Your Ref: SSD-85238209

Submission to SSDA for 16-20 Old Castle Hill Road, Castle Hill

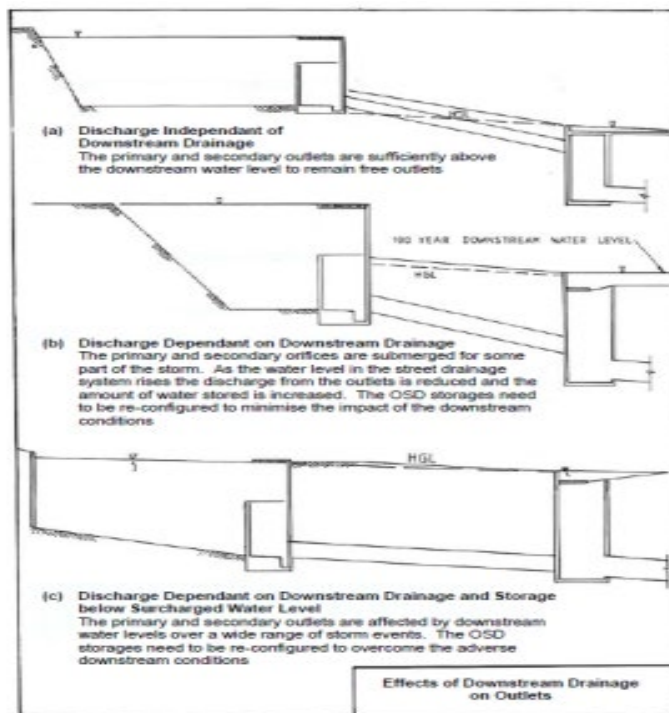
Where OSD is proposed, the OSD is shall not be impacted by "Effects of Downstream Drainage on Outlets" as it will not be supported. The OSD configuration shall be redesigned. Please refer to Figure 6.3 of the On-site Stormwater Detention R3, of the Handbook Upper Parramatta River Catchment Trust, and the snapshots below:

Options "B and C" will not be supported, therefore, ensure the depth of the OSD is reduced and Options "B and C" are avoided.
